TO:	Dr. Cone, Superintendent of Schools, LVISD	FROM:	Catherine Blackler <i>Catherine Blackler</i> Senior Project Manager, AGCM
cc:	Belinda Raindl, LVISD		Michael Rogers, AGCM
RE:	La Vernia ISD – Bond 2023	DATE:	June 18, 2025
SUBJECT:	PR No. 13	PR DATE:	April 21, 2025
PR COST:	<\$ 13,782.00>	CONTRACTOR:	Bartlett Cocke (RCO 12)

La Vernia ISD 2023 Bond Projects (231091)

Description	PR#13 - Electrical Credit per RFI026	Date	2025-05-05
Status:	Pending Review	Days Impact:

No. **RFI00026**
Printed November 19, 2024

E3.1D

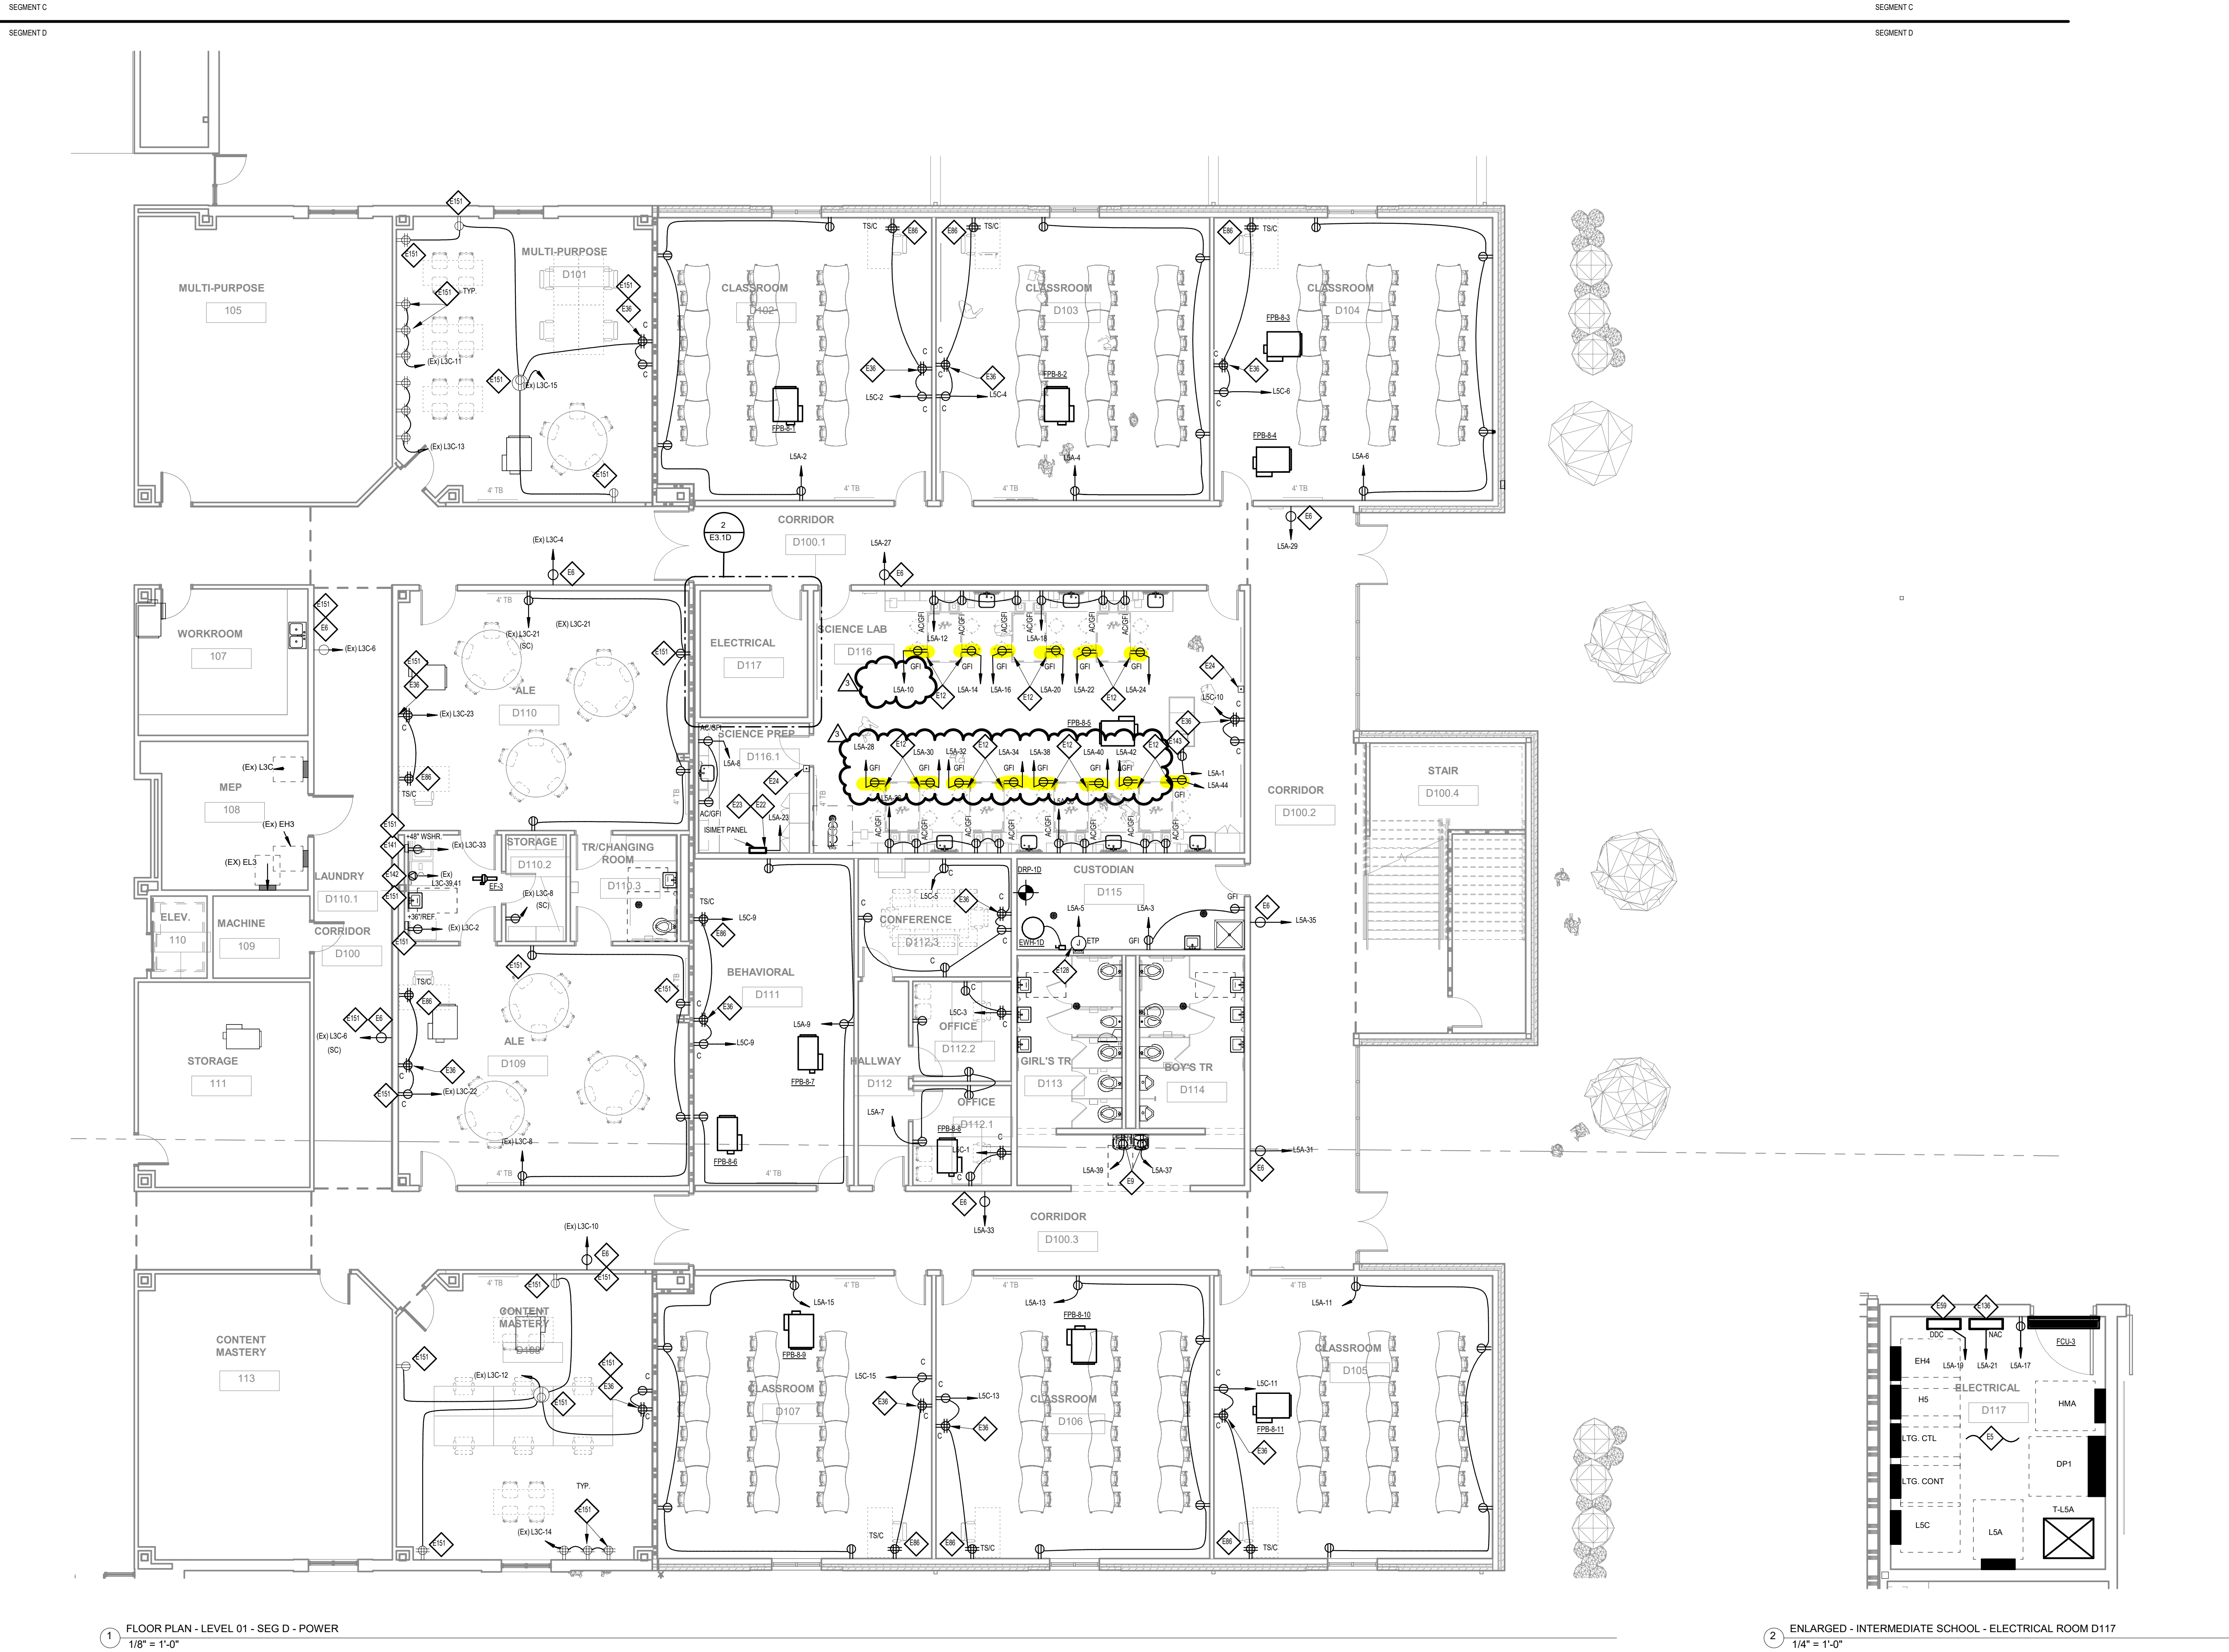
Please clarify if the science room tables are to have outlets included per electrical drawing E3.1D. Currently the spec and details for the science classroom tables do not call out for any electrical inclusions.

Science room tables are not intended to have electrical outlets. Disregard the 14 electrical outlets shown at ends of tables on sheet E3.1D.
-Braden Haley
Pfluger Architects
1.28.2025
